**TRANSMITTAL OF DESIGN CHANGE NOTICES FOR THE HAUL ROAD/RELOCATED NORTH ENTRANCE ROAD PROJECT, THE LEACHATE CONVEYANCE SYSTEM PROJECT, AND THE ON-SITE DISPOSAL FACILITY PROJECT**

**Design Change Notice (DCN) Report for On-Site Disposal Facility (OSDF) - Phase I  
Subcontract No. FY 597**

Sketch \* 20120-3K-013  
DCN 1698/99-033

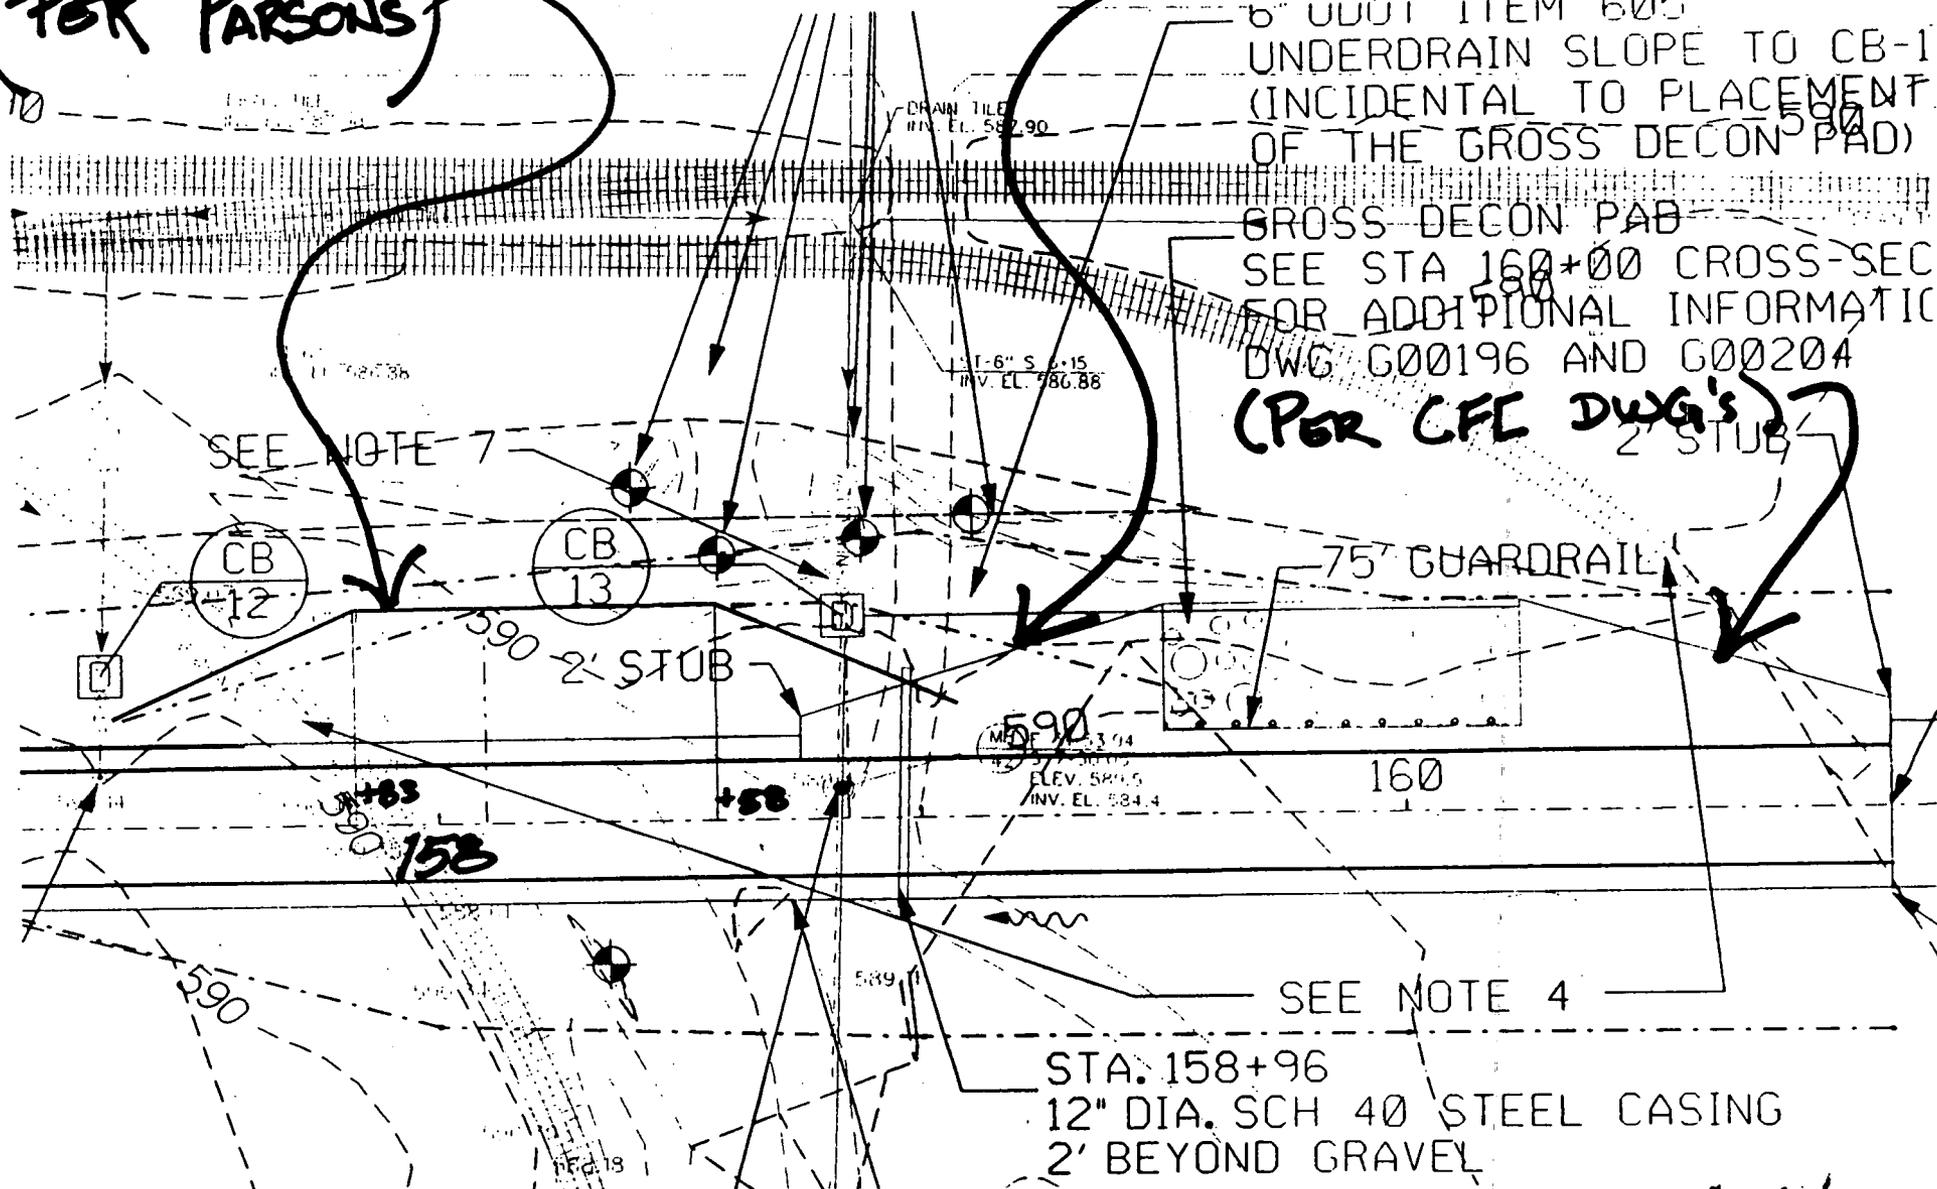
(PER PARSONS)

(PER FDF DCN)
